17 July 2012

TNO 2012 R10080

TNO review of IMARES report 'Assessment of the Effects of the Offshore Wind Farm Egmond aan Zee (OWEZ) for Harbour Porpoise (comparison T0 and T1)'

IMARES comment (final) to TNO comment

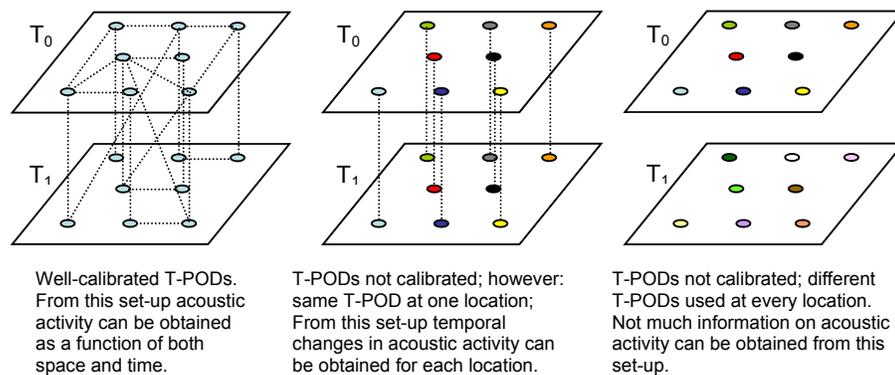
Unfortunately, some of the T-PODs were lost during the experiment. They had to be replaced by other devices. The original T-PODs were of the type V3 whereas the replacement T-PODs were of the type V5. This means that the original experimental set-up (‘same T-POD at same location’) could no longer be maintained. The result is the set-up according to the right picture of Figure 2 (‘various T-PODs at same location’). As a consequence, a careful intercalibration between the various T-POD devices to be used at the same measurement location is required in order to satisfy the original experimental set-up requirements (middle picture of Figure 2).

In summary: because individual T-PODs may differ, it is important to use the same T-POD at each particular location throughout the experiment, or, if this is not possible, to carefully intercalibrate the T-PODs to be deployed at the same location.

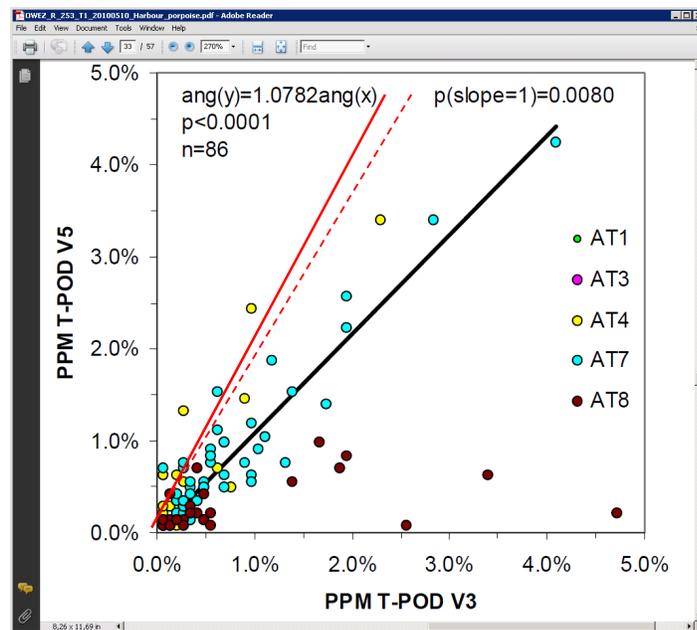
Figure 3 (which is a copy of Figure 17, p.36 in [1]) displays the result of the overall V3-versus-V5 calibration. From this figure, we get the strong impression that at location AT4, the V5 version is much more sensitive than the 8% that has now been adopted for PPM, see the yellow dots. In particular, it seems that if location AT4 would have been excluded from the analysis (as was location AT8), then the general intercalibration of V3-versus-V5 would be close to the line $y = x$ (i.e., mainly based on the intercalibration at location AT7), meaning that V5 and V3 are equally sensitive at AT7 outside the wind farm. However, the individual AT4 V3-versus-V5 calibration (red dashed line, added by TNO) would be close to the line $y = 2x$ (red solid line, added by TNO). It means that V5 seems to be almost twice as sensitive as V3 at AT4 within the wind farm.

IMARES has commented on our question to clarify this issue at location AT4 as follows: 'The short answer to the question is that yes, it appears that the slope of AT4 is higher than 1, but this was not statistically significant and hence not discussed' (email dd. 7 June 2010), see also p.44 of [1].

Note that AT4 is a very important location as it is one of the two locations inside the wind farm. We therefore had expected a more elaborate discussion, e.g., an explanation why the effect was not statistically significant (e.g., not enough data available?).

Note that the intercalibration of V3 and V5 type T-PODs could only be carried out for five of the eight locations, see Figure 3. However, from the figure it is clear that almost all available data refers to three locations, of which location AT8 had to be discarded (too many outliers). As a consequence only two locations remained: one inside the wind farm area, AT4, and one outside the wind farm area, AT7.

In conclusion: Figure 3 suggests that the two TPODs used at location AT4 inside the wind farm had a larger difference in sensitivity (higher sensitivity during T1 than during T0) than the factor of 1.08 as applied by IMARES.

Concerning figure 17 TNO states that “we get **the strong impression** that at location AT4, the V5 version is much more sensitive than the 8% that has now been adopted for PPM, see the yellow dots.”

It is difficult to interpret if a sensitivity is significantly different or not for a specific station / T-POD based on looking at a figure. IMARES has therefore done a detailed analyses, which can be found in the report. The results show that **AT4 does not have a statistically significant effect**. It did show that AT8 did have a significant effect and therefore it was removed in the later analyses (see below).

For PPM there were significant differences among the station-specific slopes ($F_{4,108}=11.61$; $P<0.0001$), but this significant difference was entirely due to the observations from AT8. **There were no significant differences among the station-specific slopes when excluding observations from AT8 ($F_{3,82}=1.74$; $P=0.1654$)**. PPM was significantly higher ($\sim 8\%$) for v5 than v3 when observations from AT8 were not included in the intercalibration regression (Figure 17).
